**NEW PRIMARY SCHOOL IN EDMONDSON PARK
BUCHAN AVENUE, EDMONDSON PARK, NSW 2174
DESIGN BCA COMPLIANCE REVIEW (SSDA DESIGN STAGE)**

SCHEMATIC DESIGN BCA COMPLIANCE REVIEW

PROJECT NO.	GDL 210133
Property Details	New Primary School in Edmondson Park
Client	Richard Crookes Construction Pty Ltd
Date	18.05.2021

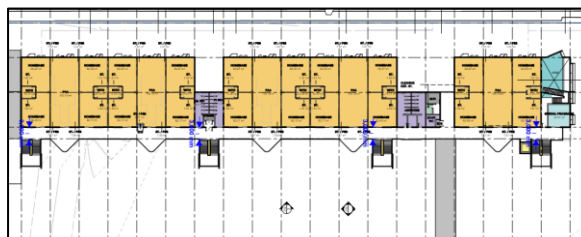
The external stairs are interconnecting 3 storeys and located closer than 6m (4m approx.) from the external walls, thus additional protection in accordance with Clause D1.8 will be necessary, or the stairs are to be pushed away from the building further to achieve compliance.

As the stairs serving 3 levels are not fire isolated stairs, it appears that the proposed design pursues the inclusion of “external stairs in lieu of fire-isolated stairs” in compliance with Clause D1.8 which is considered suitable. However, please ensure the following requirements are met:

- Stairs must be made of non-combustible material throughout; and
- Stair egress is to be located at least 6m from the external wall of the building as a minimum.

Alternatively, the following measures may be pursued:

- Walls portions closer than 6m from the stairs (3-6m) are to be provided with 1hr FRL for a wide distance and any associated openings to be protected in accordance with Clause C3.4. No openings closer than 3m are allowed to the stair or
- Provide sprinkler system throughout the buildings (all of them), or
- Design the stair to ensure it does not provide access (no Circulation internally) and it is separated from the extra storey (1 storey) by a 90 mins FRL construction and smoked proofed on the Ground Floor.
- Pursue a Fire Engineering Performance Solution.

APPENDIX B – IDENTIFIED EXITS & TRAVEL DISTANCES

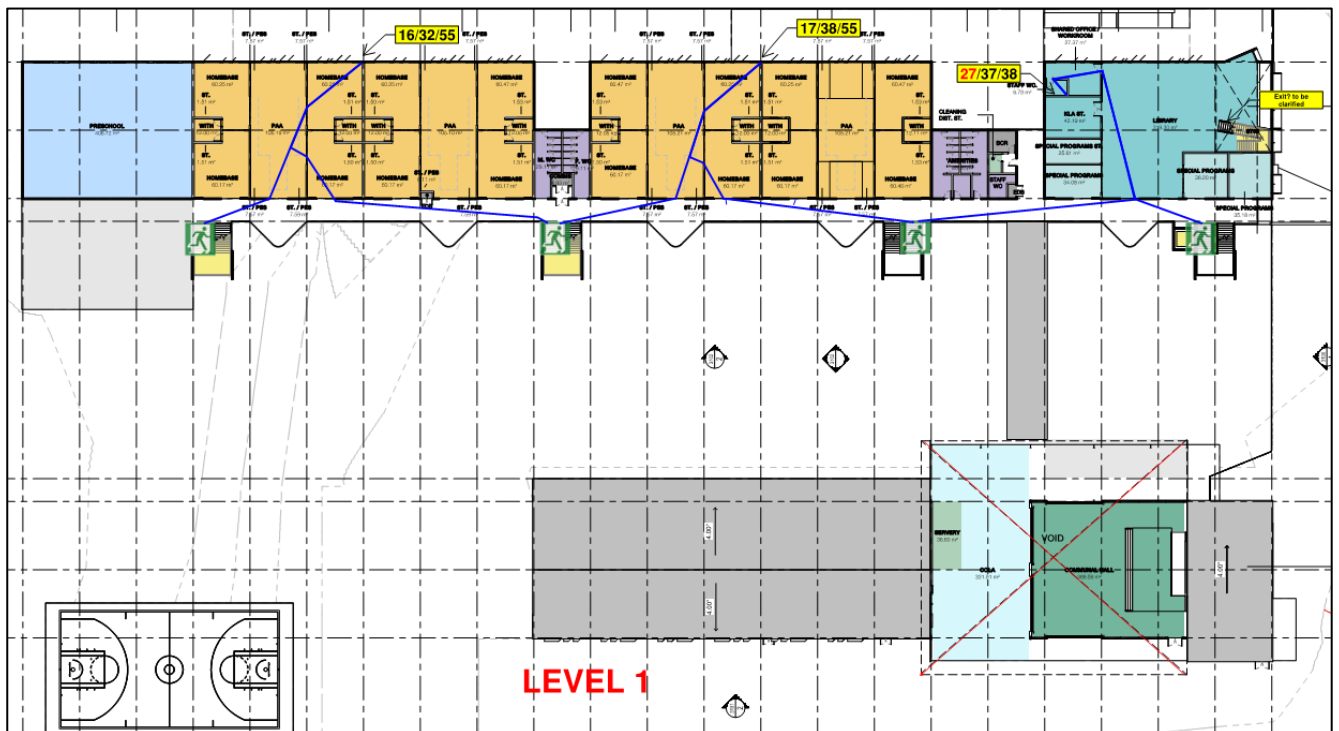
Note: Alternative Exit Routes on Ground Floor area are needed to be detailed, as points of choice need greater separation.

Note: Alternative Exit Routes on 1st Floor area are needed to be detailed, as points of choice need to egress through other home base and sliding doors, so latching and exit sign detailing to be provided

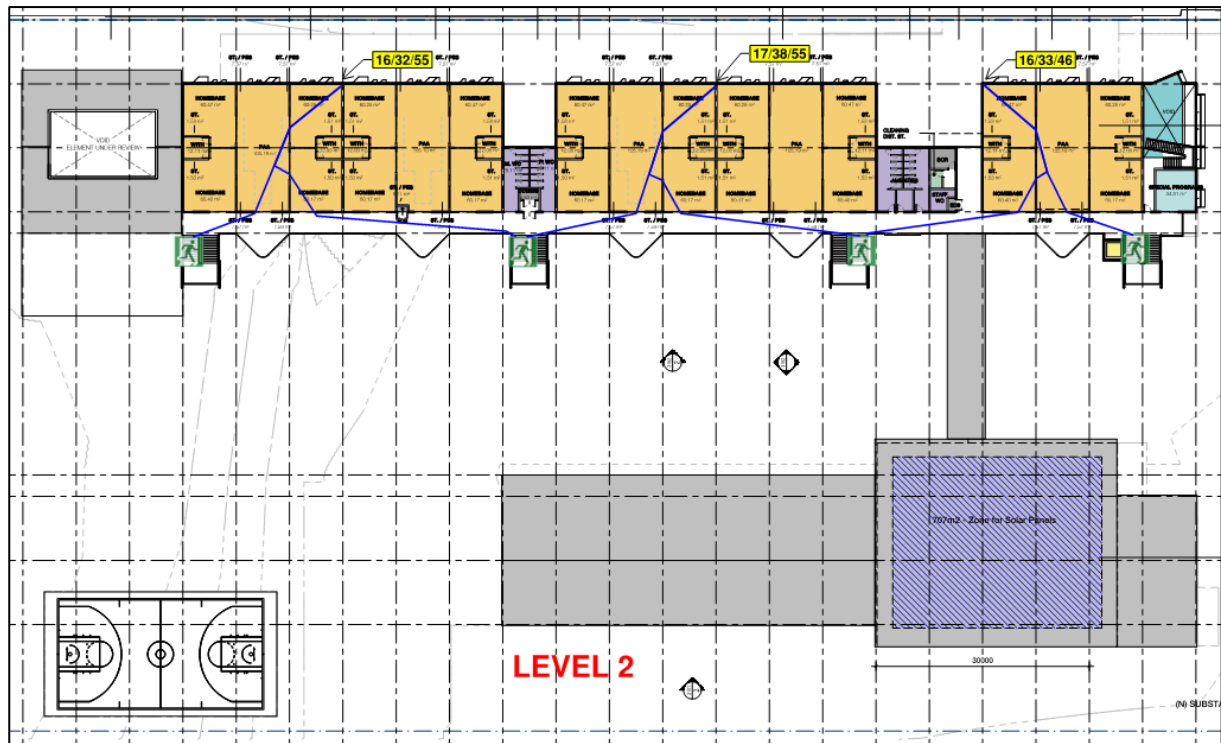
Note 2: Circulation stair in Library is not an exit, and for BCA Compliance cannot be used as an exit..

Important Note: In order to achieve the 20m to a point of choice, egress splits internally with the Home bases / Buildings as indicated – this will need to be coordinated with Architect (door latching/provision), Electrical Consultant for Exit sign locations to indicate alternative egress paths and security to ensure doors in paths of travel are not secured and provided with 24/7 egress as no Fail Safe release is possible in this school.
